**Agenda
Planning Commission
Council Chambers
Wednesday, October 22, 2014 - 7:00 P.M.**

**Staff Review of Site Plan Application
UPS Overflow Parking Lot
540 S Mansfield**

To: Planning Commission

Subject: 311 S Grove, Complete Auto Site Plan Review

SHEET NAME
REMOVAL AND SESC PLAN

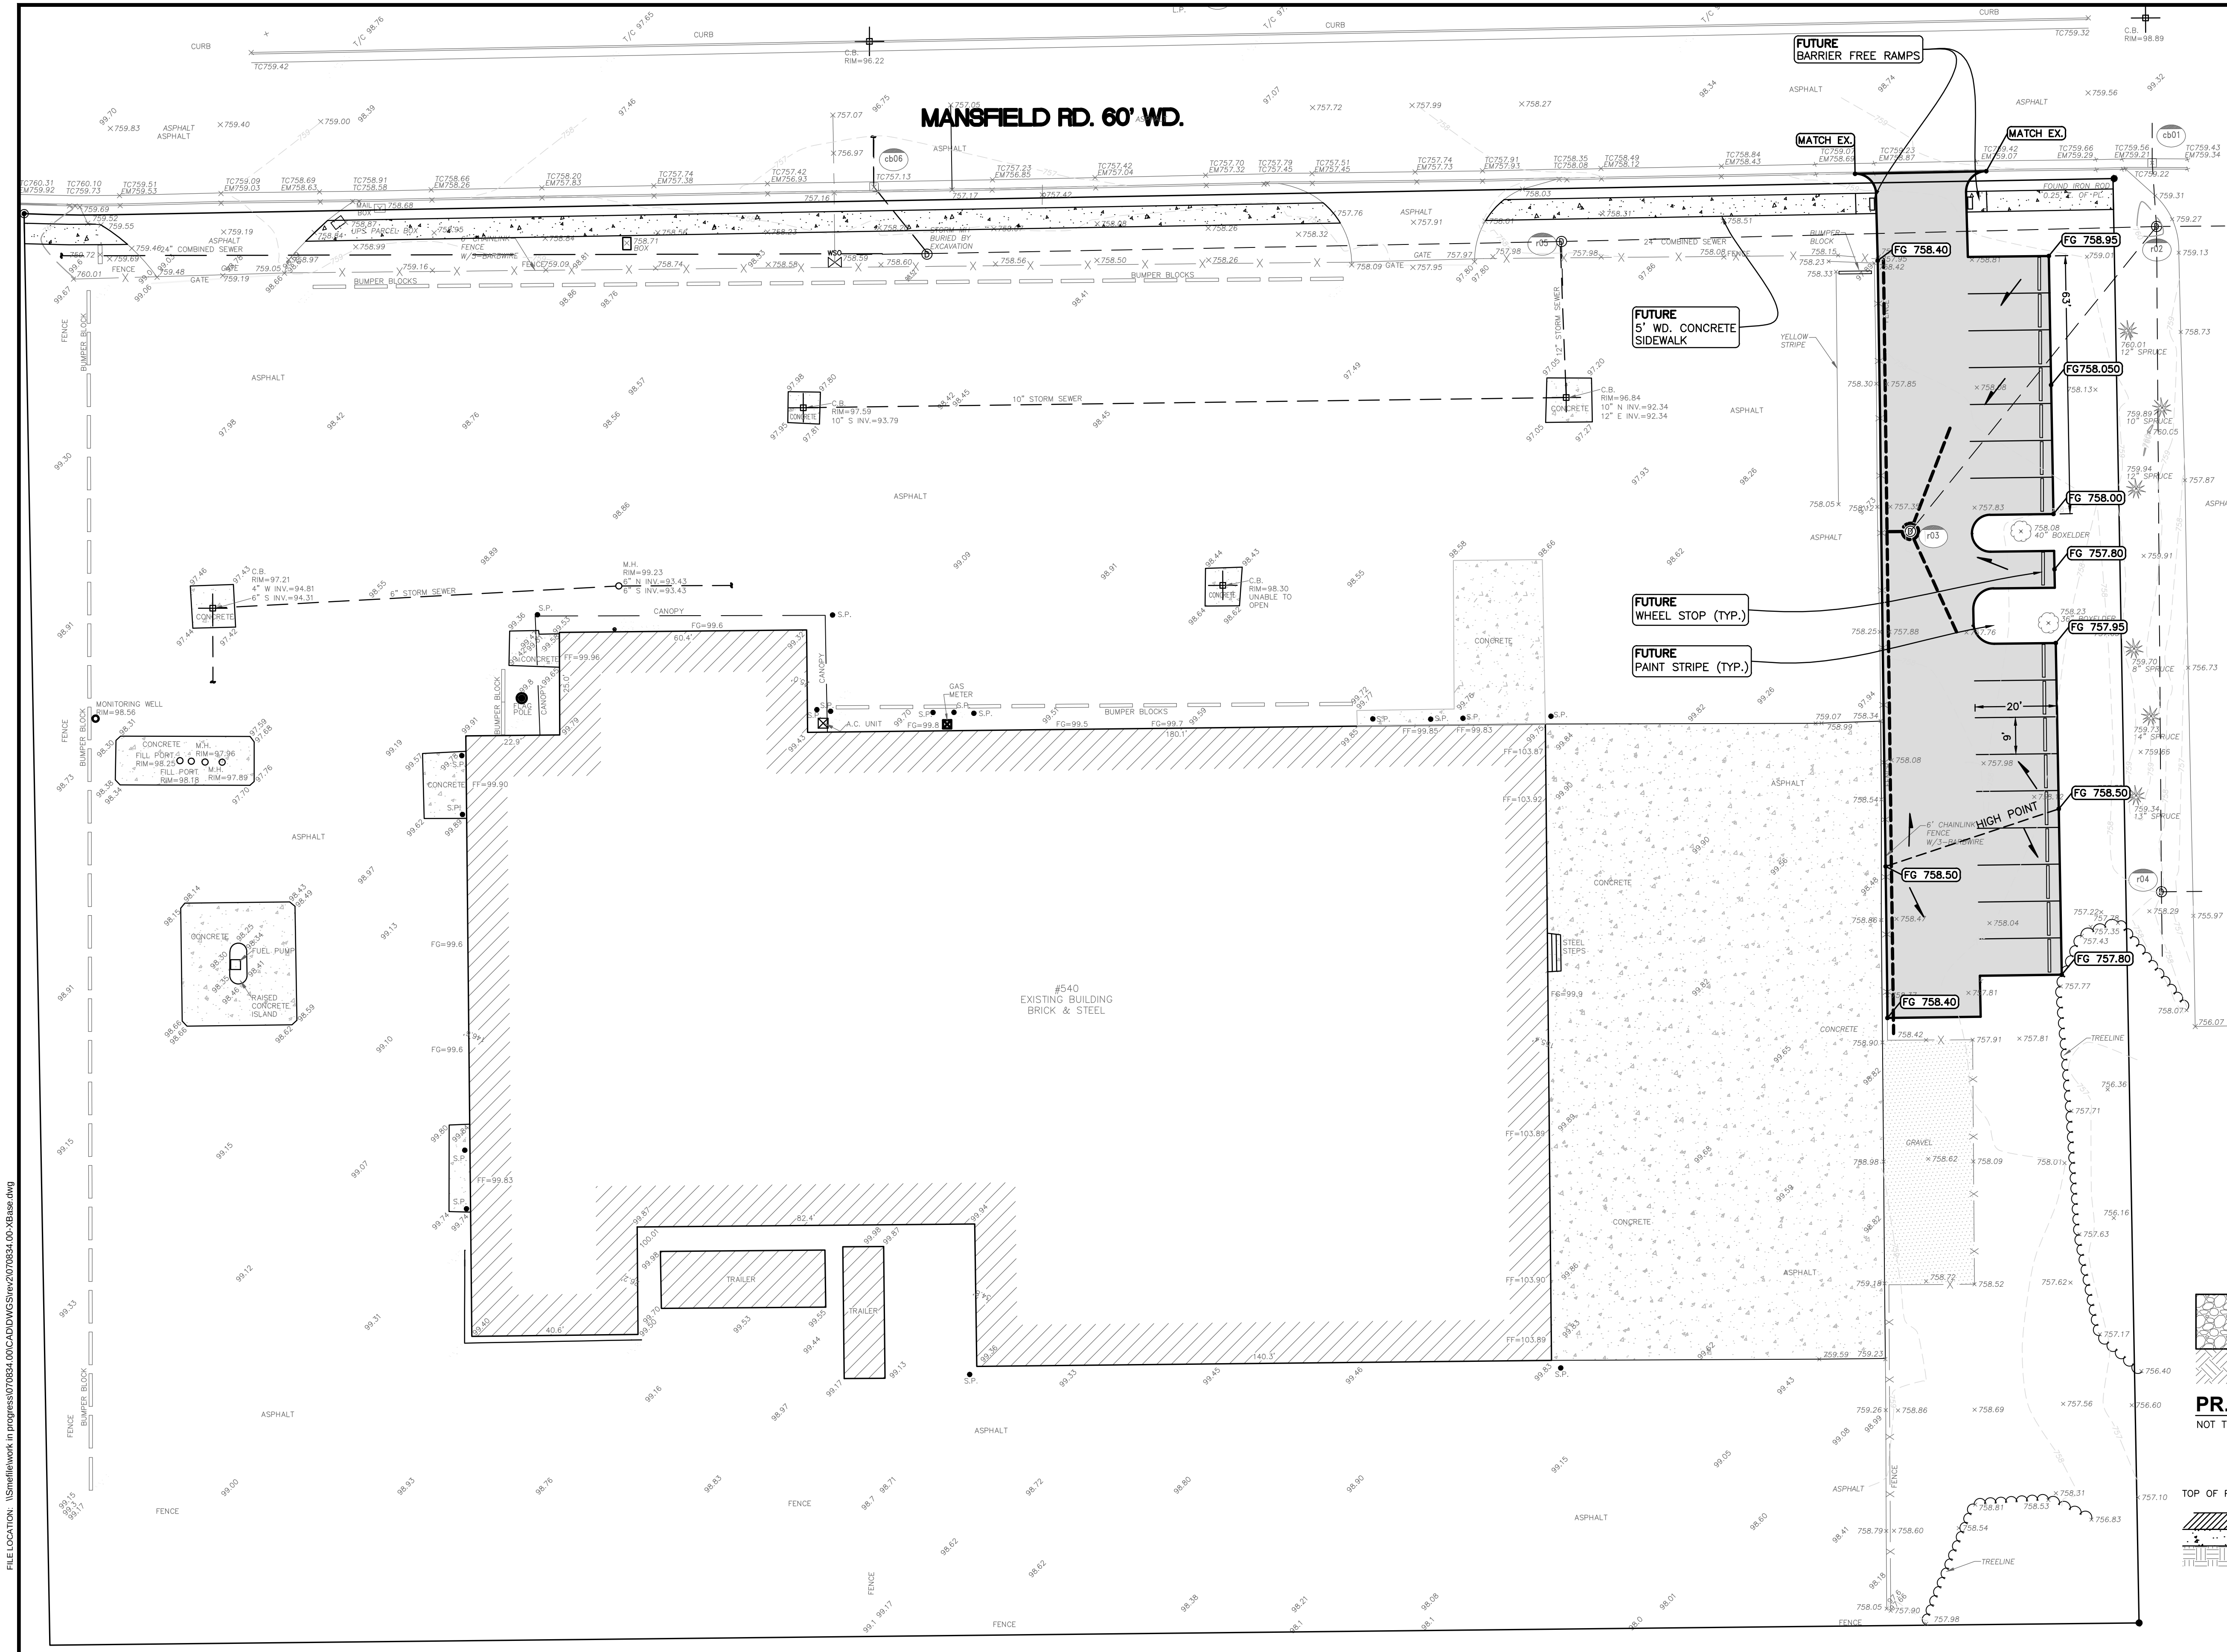
1. Clarify treatment of sidewalk during this season.
2. As development is to be phased, clarify sidewalk treatment in the initial phase.

1. Consider adding new lighting, perhaps even temporary generator-mounted lighting for the coming season, or redirecting existing lighting to serve overflow parking.
2. Planning Commission waiver requested to accept lack of curbing.

1. Applicant to bond prior to installation of gravel parking area for the construction of permanent overflow parking area and sidewalk in calendar year 2015.
2. Applicant to provide lighting for overflow parking area.
3. Applicant must obtain a permit from the Department of Public Works prior to constructing anything in the right-of-way.

MODIFIED SITE PLAN

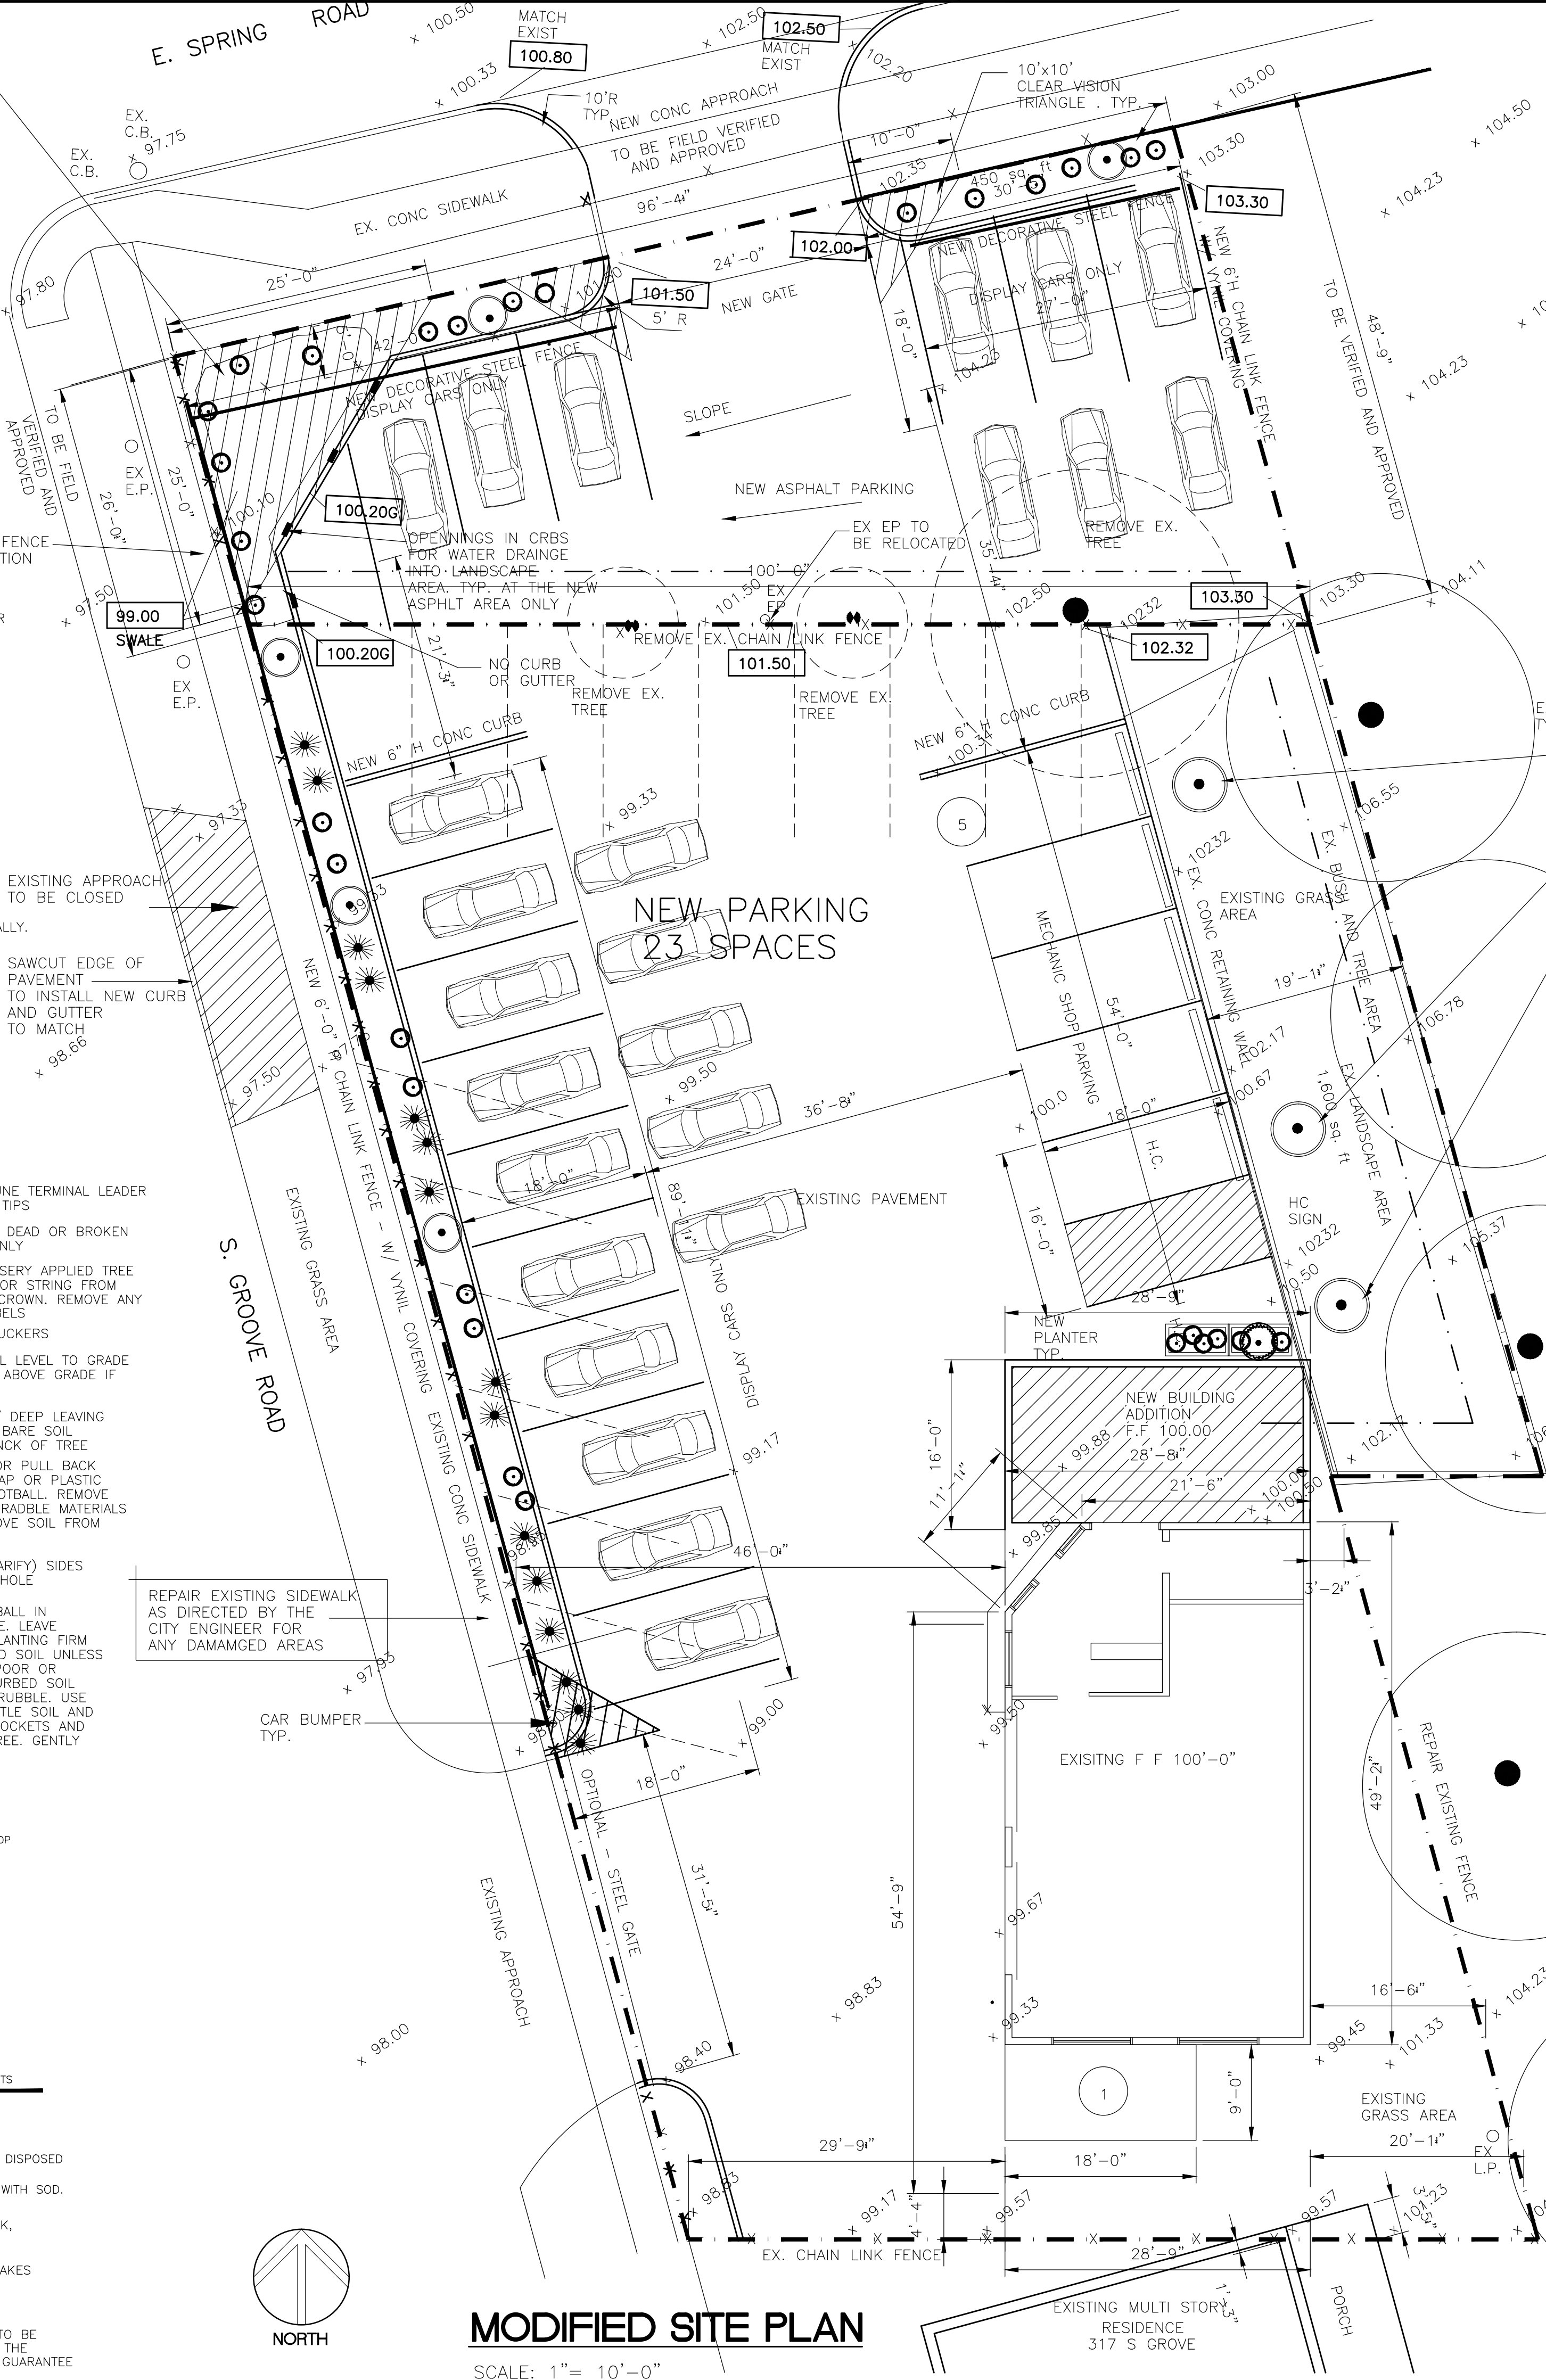
1. *Note on the site plan that minor repair only is permitted under the terms of 122-412(6), Automobile Sales. Minor Repair means "...engine tune-ups and servicing of brakes, air conditioning, exhaust systems, oil change or lubrication, wheel alignment or balancing, or similar servicing, rebuilding or repairs that normally do not require significant disassembly or storing the automobiles on the premises overnight."*

- This has not been noted.
2. *Note on site plan that all signs require a sign permit.*
 - This has not been noted.
3. *Show current outdoor lighting.*
 - Not shown.

4. *Note on site plan that no dumpster is to be used on site, and should a dumpster be used on site, it will be screened and enclosed per code.*
 - Not shown.

5. *Conditions of Rezoning:*
 - a. *Plant trees and ornamental grasses on South Grove frontage from [north] property line (chain fence) adjacent to Spring Street to [northmost] driveway on South Grove. All landscaping shall be placed on applicant's property, not in right-of-way/tree lawn.*

- Landscaping has been relocated.
6. *Parking:*
 - a. *Parking spaces & display cars shown are located in the visibility triangle. Remove.*
 - These have been removed.

- b. Revise parking area as discussed in the staff review.*
 - Display cars have been shown more densely, as suggested by staff. However, parking calculations for “display area” have not been shown, and the issue with adequate parking appears to have been made worse.

- c. Planning Commission waiver requested to permit a stall depth of 18’.*
 - Parking sizes shown as 20’ deep on notes, drawn as 18’ deep.
 - d. Planning Commission waiver requested for 20% of parking requirement.*

- Parking shown is still insufficient; correct calculations not shown.
 - e. Protect all parking aisle-ends with concrete curbs or islands.*
 - Customer parking is protected. Display parking is not.

- Curbing shown, as are openings in curb for draining stormwater.
7. *Screening, fencing, and landscaping:*
- a. Clarify location and type of screening and fencing on east property boundary.*

- Waiver requested.
8. *Engineering:*
- NOTE:** These plans have not been resubmitted for engineering re-review due to a lack of requested information.
- a. It is not clear how storm water runoff is accommodated on the existing site. Storm runoff from the site (both existing and proposed expansion) shall be captured and treated prior to discharge to the City storm system to the extent possible. Overland sheet flow to the right-of-way should be reduced as part of the site improvements.*

- Unchanged.
 - b. A note shall be added to the plans indicating "distressed or damaged areas of the existing parking lot must be repaired as part of the project". It appears a significant portion of the existing site paving needs repair.*

- d. The plans shall accurately represent the intended vehicle configuration for the display area. We note that the display area parking may not be required to conform to standard parking stall space requirements.*

- Car display area is shown as standard parking spaces.
 - e. A note shall be added to the plan stating that no new water or sanitary sewer are proposed.*

- Not added.
 - f. Cracked or settled sidewalk along Grove and Spring shall be repaired as part of this project. The plans shall identify the locations of the deficient sidewalk.*

- Locations have not been noted.
 - g. A truck circulation plan with turning movements for the largest anticipated vehicle shall be provided.*
 - Not provided.

- This has not been noted. *Noted on 10/21/2014 submission.*
2. *Note on site plan that all signs require a sign permit.*
 - This has not been noted. *Noted on 10/21/2014 submission.*

3. *Show current outdoor lighting.*
 - Not shown. *Shown on 10/21/2014 submission.*
4. *Note on site plan that no dumpster is to be used on site, and should a dumpster be used on site, it will be screened and enclosed per code.*

- Not shown. *Noted on 10/20/2014 submission.*
5. *Conditions of Rezoning:*
 - a. *Plant trees and ornamental grasses on South Grove frontage from [north] property line (chain fence) adjacent to Spring Street to [northmost] driveway on South Grove. All landscaping shall be placed on applicant's property, not in right-of-way/tree lawn.*

- Landscaping has been relocated. ✓
6. *Parking:*
 - a. *Parking spaces & display cars shown are located in the visibility triangle. Remove.*
 - These have been removed. ✓

As shown on 10/24/2014 siteplan, 11 spaces required, 10 provided. 10% Waiver requested.
